Addendum #04 for RFB #918604-01

Project Name: DHS CC Strategic Space Planning Hoover 3rd Floor Dept of Admin Services

Date: September 18, 2024

1. Per owner request, add data cabling as part of the project. This is to add cabling and the installation of the cabling only. Termination and equipment is still owner provided and owner installed.
2. Revised Drawing sheet T-000, T-103 (2 Pages)
3. Add Specification 27 1000 Structured Cabling to project manual (4 Pages)

SHEET NUMBER
T-000

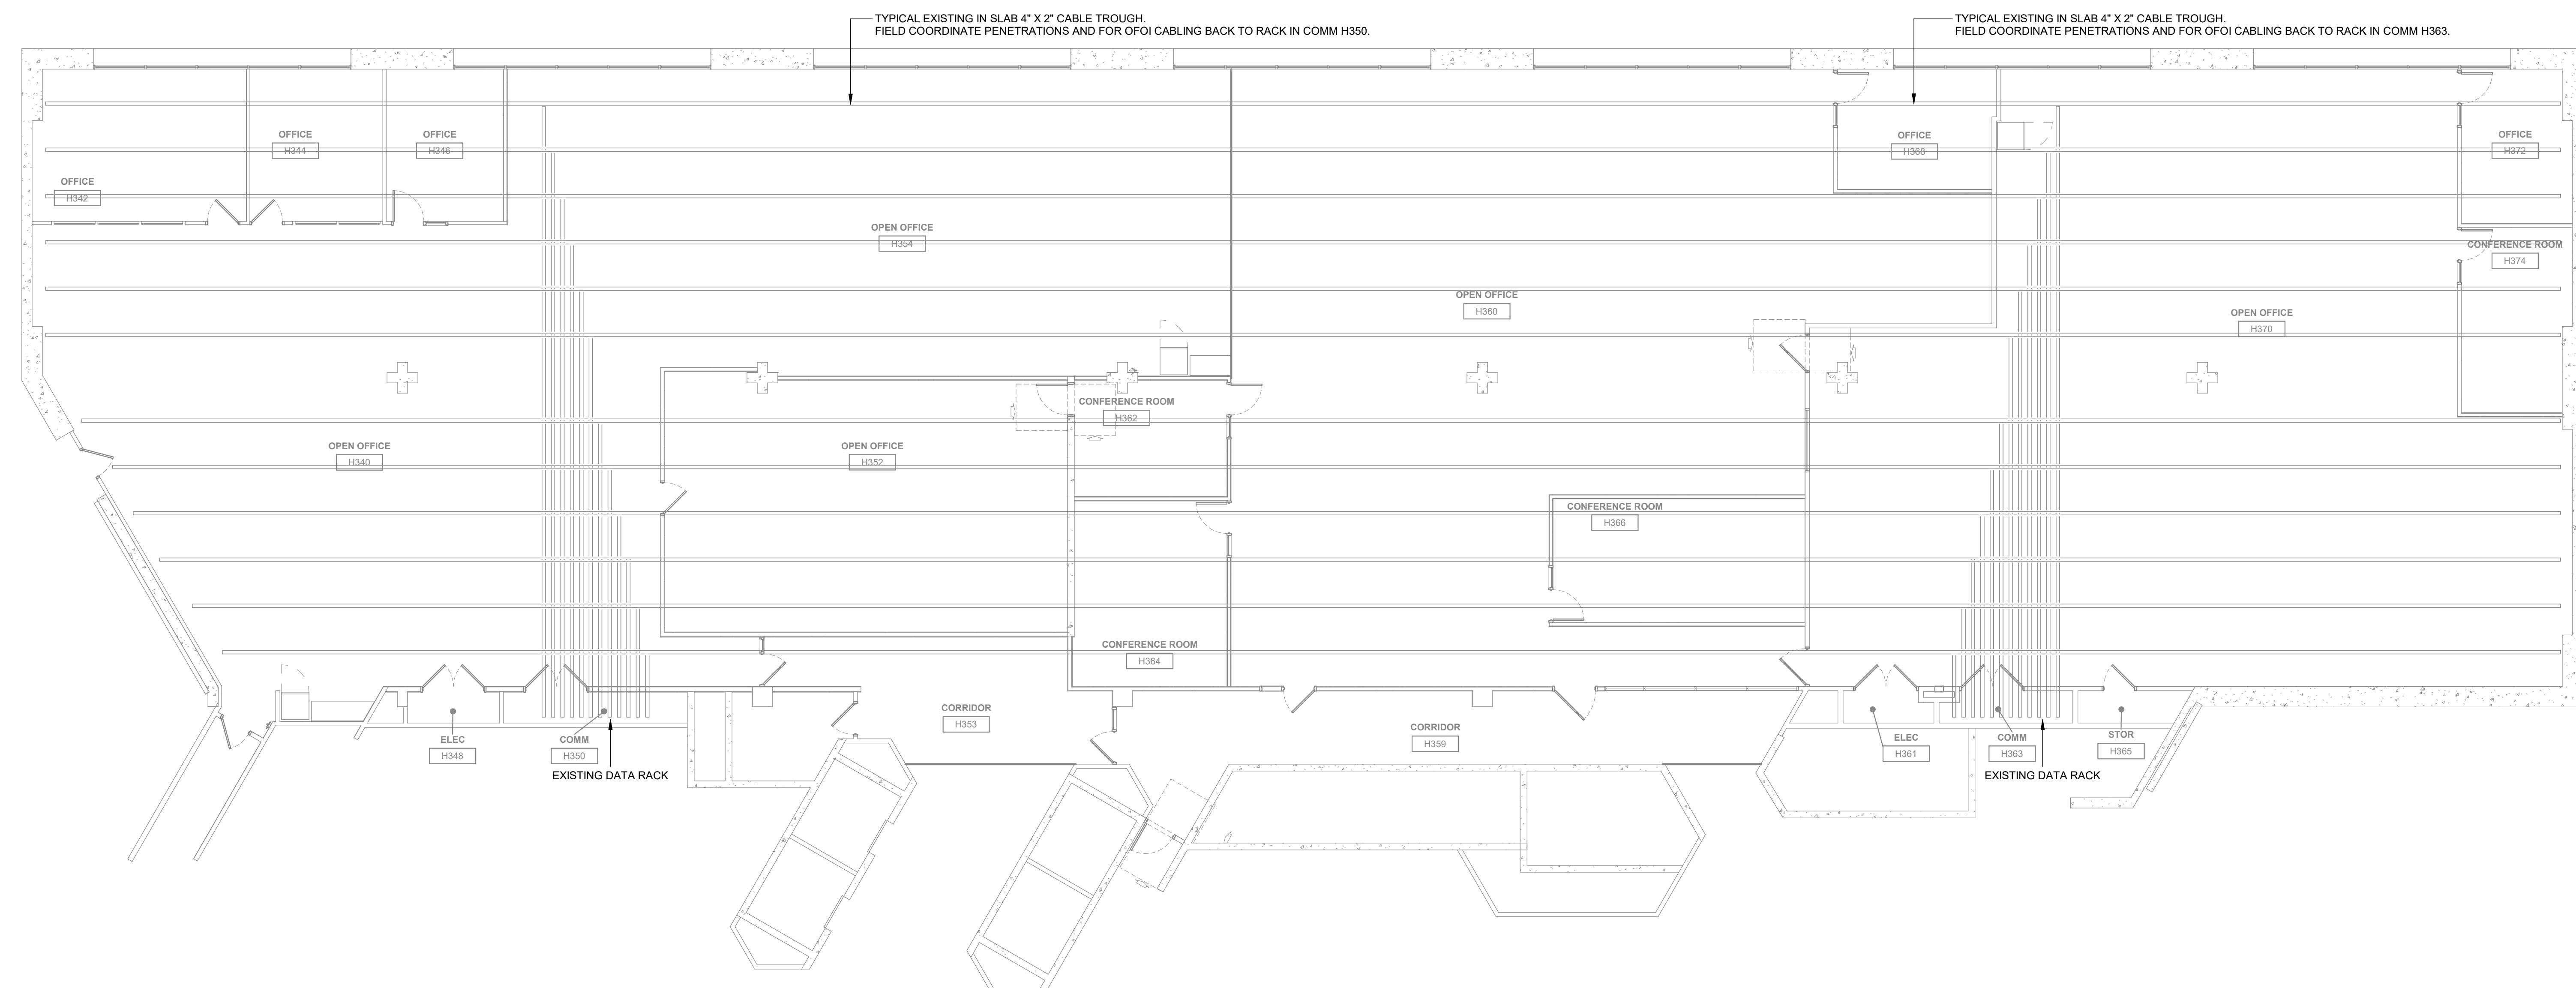
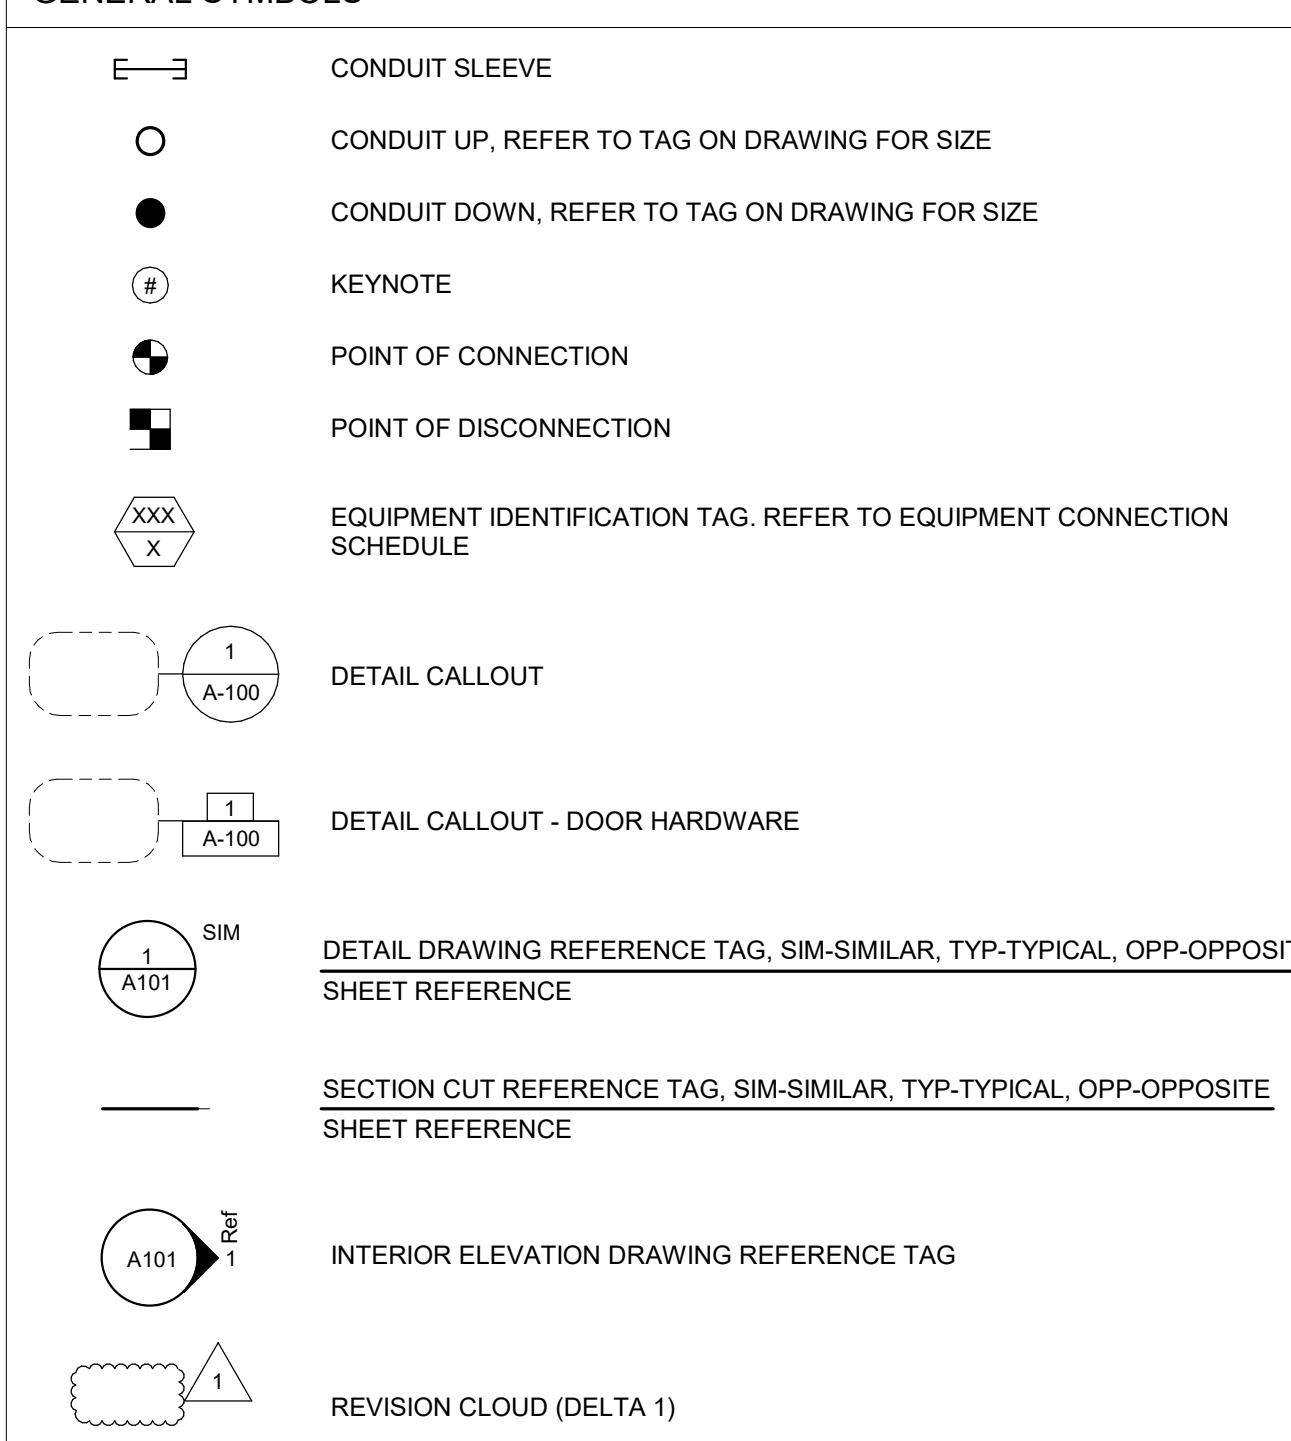
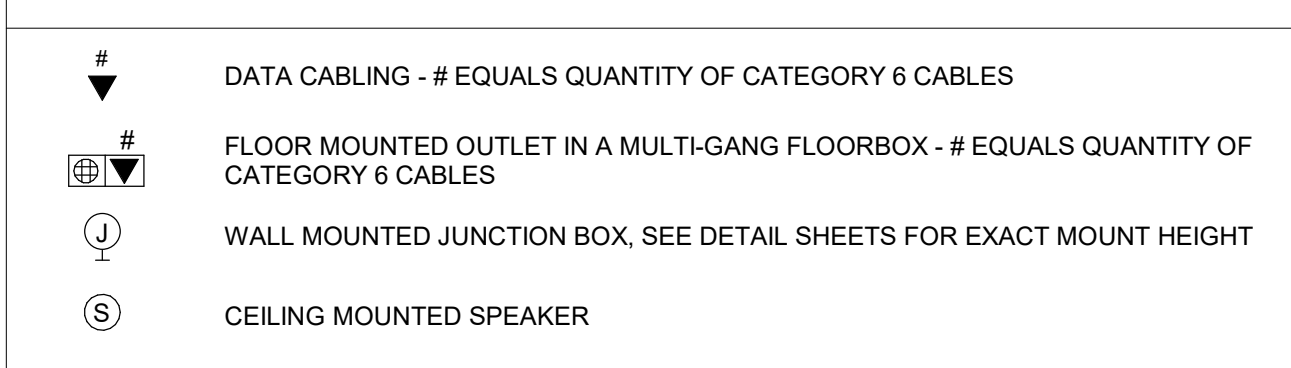
1. Drawing T-000 – TECHNOLOGY COVER
 - a. **MODIFY** Telecommunications Distribution Notes, Telecommunication Symbols, and Technology Responsibility Matrix.
 - b. Refer to attached full size sheet T-100.
2. Drawing T-103 – THIRD LEVEL TECHNOLOGY COMMUNICATIONS PLAN
 - a. **ADD** Data cable quantities to rough in locations.
 - b. Refer to attached full size sheet T-103.
 - c. Keynote #3 has been **modified**.

- 1. PROVIDE AND INSTALL CATEGORY CABLING ONLY FOR ALL LOCATIONS SHOWN. ALL TERMINATIONS, TERMINATION EQUIPMENT/DEVICES, AND HEADEND EQUIPMENT ARE OWNER FURNISHED OWNER INSTALLED.
